UNITED STATES OF AMERICA
NUCLEAR REGULATORY COMMISSION
BEFORE THE ATOMIC SAFETY AND LICENSING BOARD

In the Matter of)
SOUTHERN CALIFORNIA EDISON COMPANY,)
ET AL.)
(San Onofre Nuclear Generating Station)
Units 2 and 3))

Docket Nos. 50-361 OL
50-362 OL

WRITTEN TESTIMONY OF
JAMES N. BRUNE

Figure 4.7. Comparison of response spectrum of the dynamic slip function with that of the TERA/DELTA San Onofre slip function.

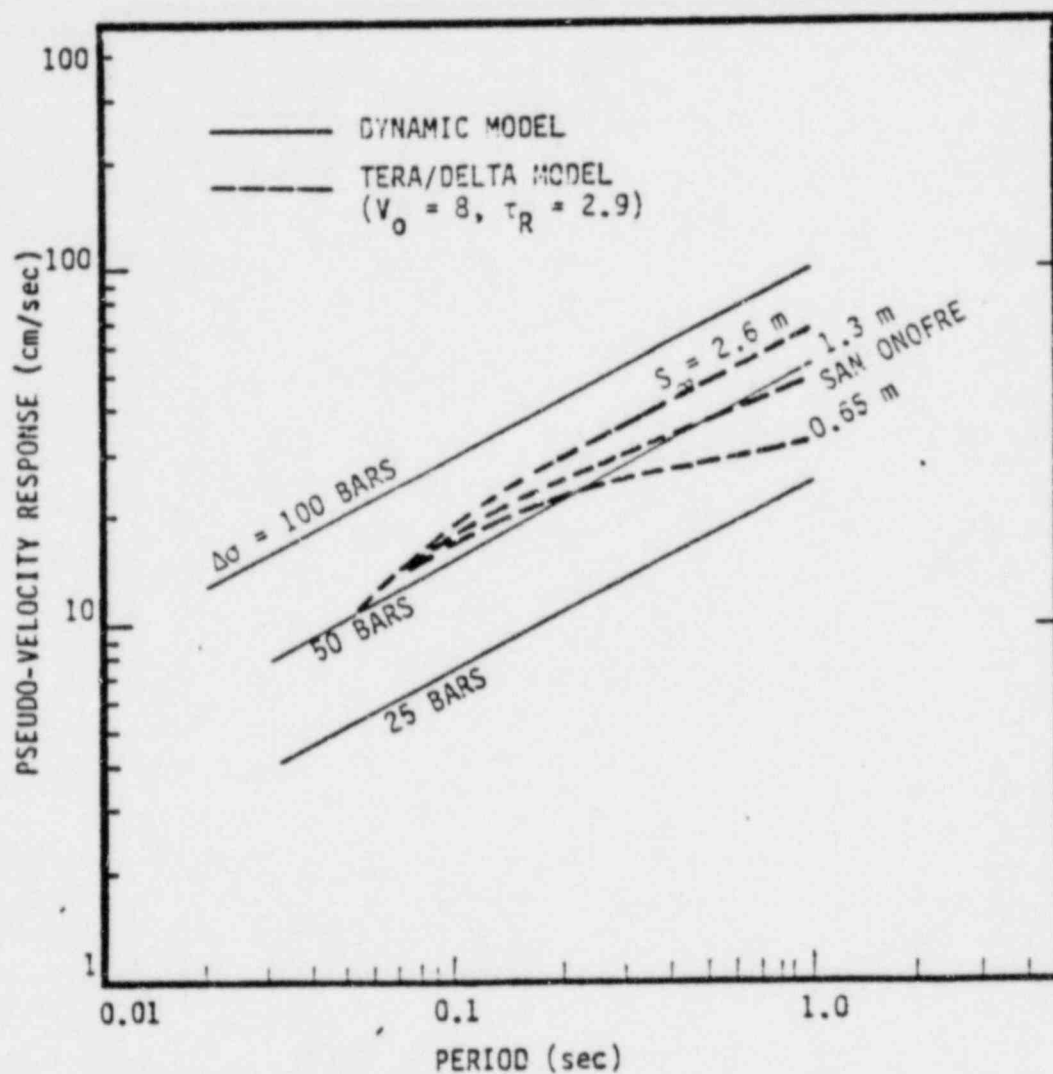
Third, because of the assumed slip function in the TERA-DELTA model, it is difficult to infer what the effective value for dynamic stress drop is. A dynamic source study comparison by Swanger et al., (1981), indicates that it is only about 50 bars (see attached figure). (There is no established basis for the assumption, made in the TERA-DELTA modeling, that the peak slip velocity parameter is constant for all earthquakes.) I feel that the average effective stress values should be varied by at least a factor of two and, in addition, the possibility of localized stress drops of up to 500 bars should be considered. The parameter studies by TERA-DELTA have shown that in the frequency range 2 to 10 Hz, the response spectra are essentially linear with respect to dynamic stress drop. Thus, to take into

account these higher stress drops, we should multiply the spectra in this frequency range by a factor of about two. Local zones of high stress drop would increase the spectra even more.

FIGURE 4-12

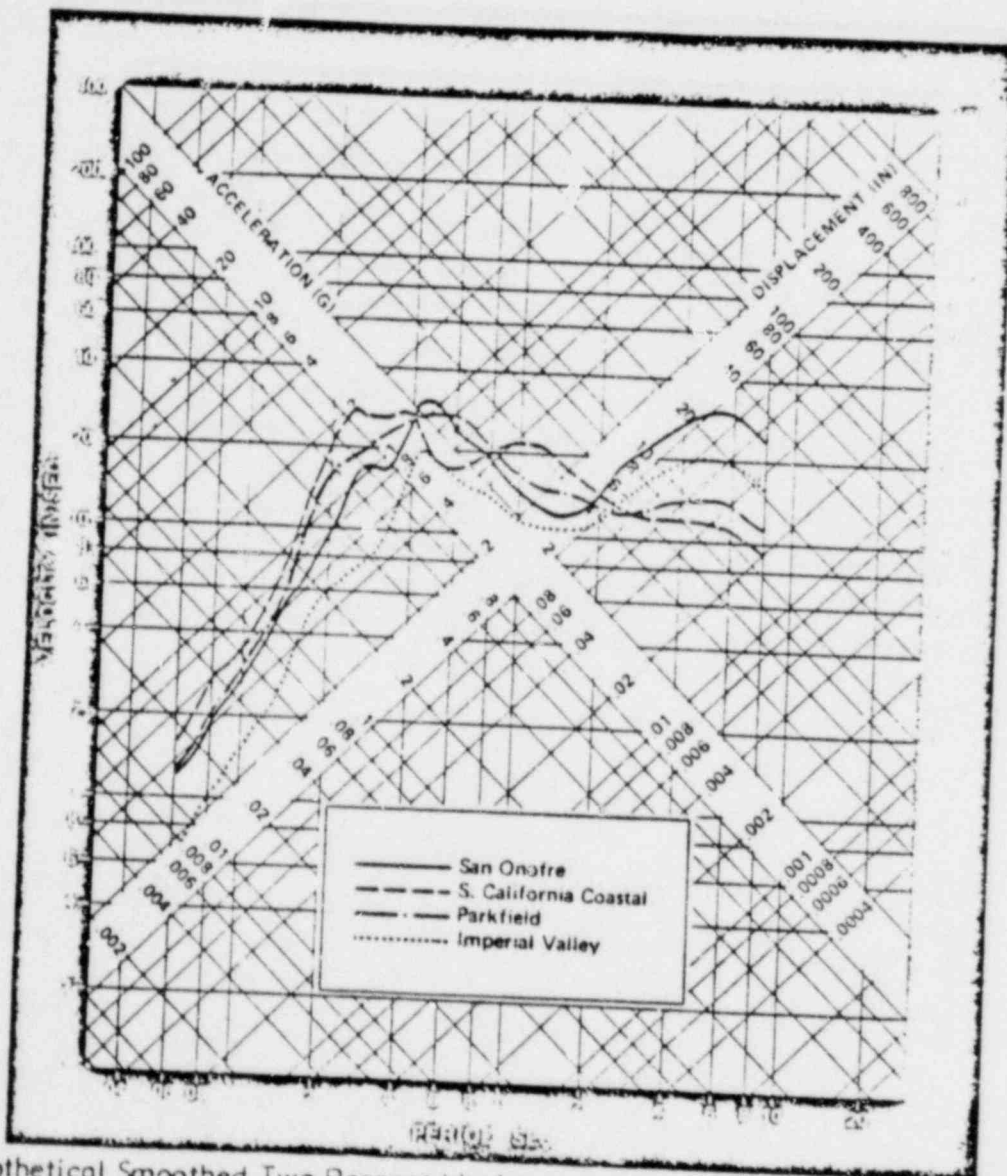
Hypothetical Smoothed Two Percent Horizontal Response Spectra that Would Be Found Were the San Onofre Site Located on Each of the Geologic Structures Illustrated in Figure 4-11.
